STAFF RECOMMENDATION

N. Witherell
NCPC File No. 6423/6636

SMITHSONIAN INSTITUTION
PERIMETER SECURITY AT THE NATIONAL MUSEUM OF NATURAL HISTORY
The National Mall, Constitution Avenue between 9th and 12th Streets, NW

January 26, 2006

Plan detail at Madison Drive museum entrance – Base Option

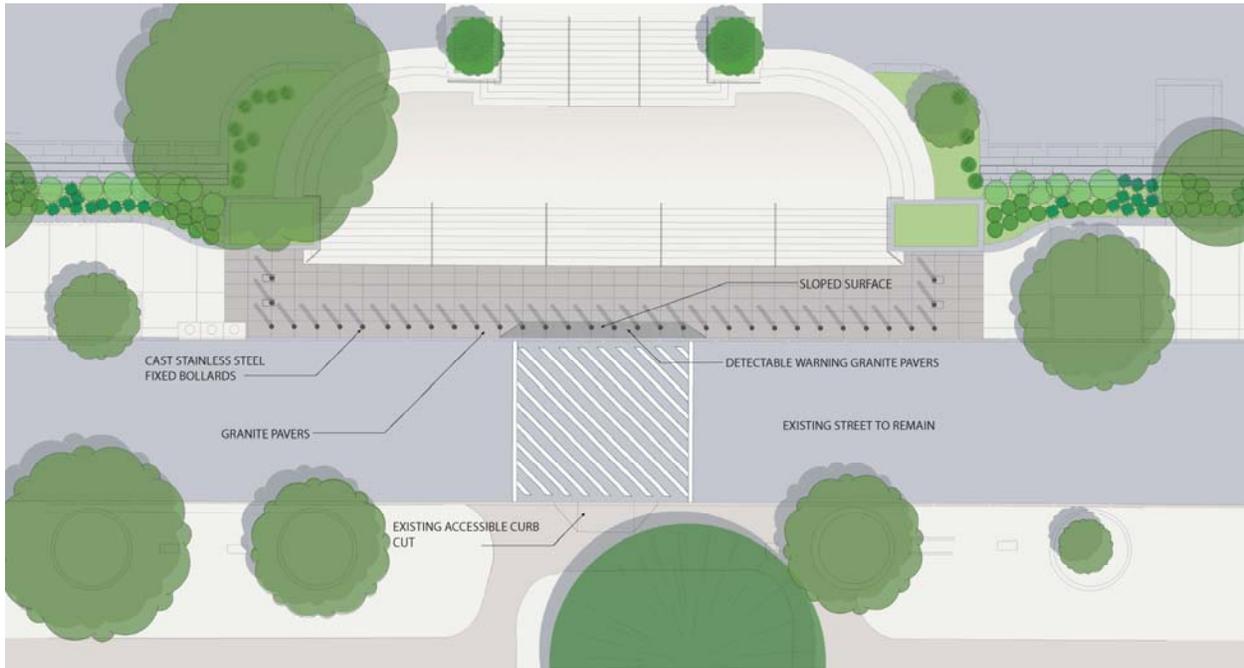
“Base Option” at entrance: The staff was among the many agencies and organizations that consulted with SI in mock-ups of bollards at various locations in front of the entrance during the development of this scheme. At the museum entrance, bollards will be installed around the stairs at the Madison Drive street curb. A custom cylindrical, cast stainless steel bollard was developed for the site, for both fixed and operable bollards. The bollards will cross the Madison Drive sidewalk and run parallel to the street curb. The sidewalk (of granite pavers, extending the width of the museum entrance and replacing the current concrete sidewalk) will be sloped imperceptibly toward the street in order to reduce the width of the handicapped sidewalk parallel to the curb. The ramp has also been widened to the width of the stairs to provide a more formal and well-integrated sidewalk design and to reduce the potential for the bunching of pedestrians crossing the street. “Detectable warning” granite pavers, of matching stone but with a raised pattern, will edge the curb. The bollard line will run across the sidewalk ramp. While the height of the bollards would be uniform across the line, the bollards crossing the ramp would be longer (lower) by about two inches to accommodate the slope. The design adjustment to both the sidewalk slope and to the length of the sidewalk ramp minimizes the difference in heights of the bollards and the perception of them.

The Commission previously commented on the location of the bollards at the south entrance, recommending the relocation of the bollard line away from the curb so as to "minimize conflicts with pedestrian movement along the sidewalk." After studying various locations at the site with mock-ups, the many participants from review agencies and interested groups found that the best solution was to place the bollards near the curb, rather than in the middle of the sidewalk or close to the base of the stairs. The SI believes that keeping the bollards away from the base of the museum stairs is a safer option for museum visitors using the stairs, and that it also improves the appearance of the stairs as a significant element of the building's façade, as seen from the Mall.

Approves the final site and building plans for perimeter security around the National Museum of Natural History, with the "Base Option" treatment for the Madison Drive entrance, as shown on NCPC Map File No. 1.41(38.40) 41956.

Plan detail at Madison Drive museum entrance – Option 1

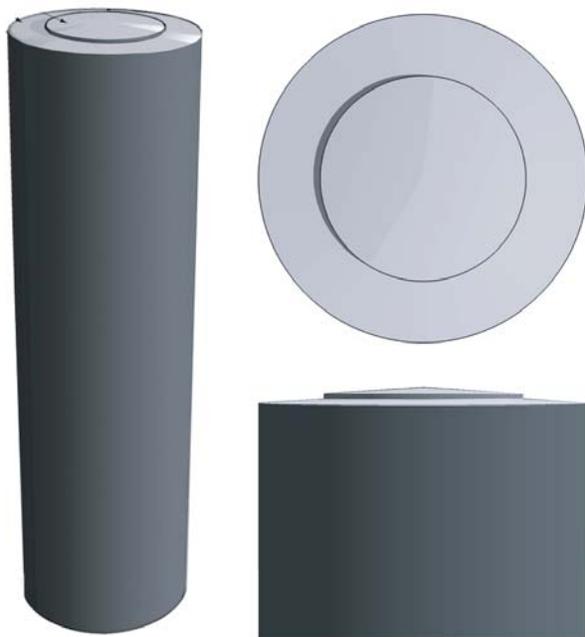
“Option 1” at entrance: Another option, also developed during design consultation, is to raise the level of Madison Drive in front of the museum in order to eliminate the curb. The raised street table, of granite, would extend the width of the museum stairs and replace the striped crosswalk. The bollard line would be installed in the same location as in the Base Option, but the perception would likely be of a more spacious entrance. The bollards would be of a uniform size because the sidewalk ramp would be unnecessary. The detectable warning pavers, however, would still be installed. SI has consulted with the National Park Service in the development of this option, as the Park Service has jurisdiction of Madison Drive. If this option is implemented, SI will assume the maintenance of it.

The staff recommends that the Commission approve both the Base Option and Option 1 for the sidewalk configuration. Staff prefers Option 1 (which will require further funds for construction and for subsequent maintenance) because it provides a more spacious appearance to the sidewalk and eliminates the need for a sidewalk ramp and painted stripes in the street in front of the museum. SI has consulted with the National Park Service (which concurs with Option 1), since that option would be constructed on land in the current maintenance jurisdiction of the National Park Service.

Recommends that the "Option 1" treatment for the Madison Drive entrance be implemented, as also shown on NCPC Map File No. 1.41(38.40) 41956.

Detail of plan at Constitution Avenue entrance

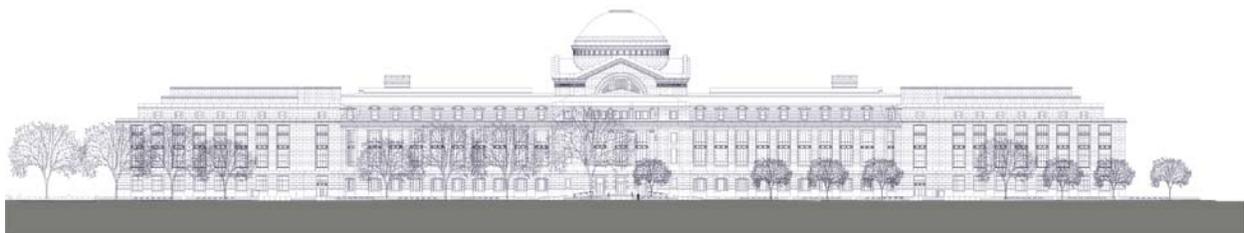
Individual bollards are installed at the driveways and across the grass panels and the walkway at the north entrance to the museum. The current entrance driveway will be modified slightly. The significant tree near the entrance will be retained and another will be planted. The stairs have been reconfigured slightly and ADA-compliant railing will be added. The sign wall that the Commission objected to in the previous scheme has been eliminated. The museum identification sign is now placed in the lawn near the building entrance. Two custom-designed, granite-faced guard booths are proposed for the driveways entering from Constitution Avenue; the booths are integrated into the granite free-standing wall.

The proposed new free-standing wall along Constitution Avenue is also the result of further study of the site. The elimination of the existing granite curb from the scheme has allowed the design team to simplify and streamline the free-standing wall along a 1000-foot length of Constitution Avenue. Staff supports the removal of the curb for two reasons: it allows for a unified and simplified barrier wall instead of the composite barrier previously proposed (which consisted of the coping stone curb adjacent to and affixed to a vertical barrier fence); and it allows the trench for the barrier fence to be placed as far away from the tree roots as possible.

The revised design for the north façade barrier is more contemporary than previously shown. The proposed custom bollard for both north and south entrances is a sleek cylinder of stainless steel that will serve as both the fixed and the retractable bollards--rough, dark grey cast stainless steel for the body and polished stainless steel for the top. The rhythm of the wall elements has been studied in relation to the building façade and to the landscape. The fence wall is open for views of the lawn. Instead of the benches recommended by the Commission, the fence wall contains lower curb sections similar to the curb that is currently used as seating. The staff finds the simplified, contemporary custom design to be appropriate for security design at this Beaux Arts-style building.
